# SS 783-WST Progressive Low Voltage Disconnect Parameter Update

57X vehicles built between July 1st, 2021 and February 5th, 2025.

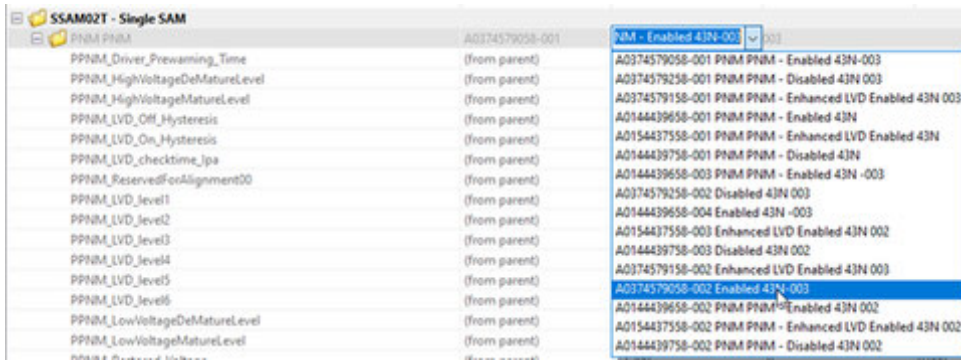
4. Expand the **SSAM02T**, expand the **PNM PNM** group.
5. Select the part number below in the drop down menu for the PNM group as shown below. **The selection needs to be the next revision of the currently equipped parameter. Please see table below for reference.**

**Example: A0374579058-001 Enabled 43N-003 → A0374579058-002 Enabled 43N-003**

Parameter	Part	Value	Unit
PPNM_Driver_Prewarning_Time	(from parent)	60.00	s
PPNM_HighVoltageDeMatureLevel	(from parent)	15.50	V
PPNM_HighVoltageMatureLevel	(from parent)	16.00	V
PPNM_LVD_Off_Hysteresis	(from parent)	60.00	s
PPNM_LVD_On_Hysteresis	(from parent)	60.00	s
PPNM_LVD_checktime_lpa	(from parent)	10	min
PPNM_ReservedForAlignment00	(from parent)	0

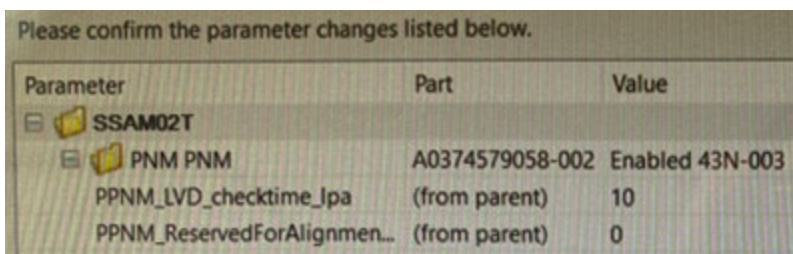
6. Verify the adjusted parameters are showing the correct values. If matching the values below, click **Send**.

**Note: These two parameters are the ONLY adjustments.**

**PPNM\_LVD\_checktime\_lpa = 10**

**PPNM\_ReservedForAlignment00 = 0**
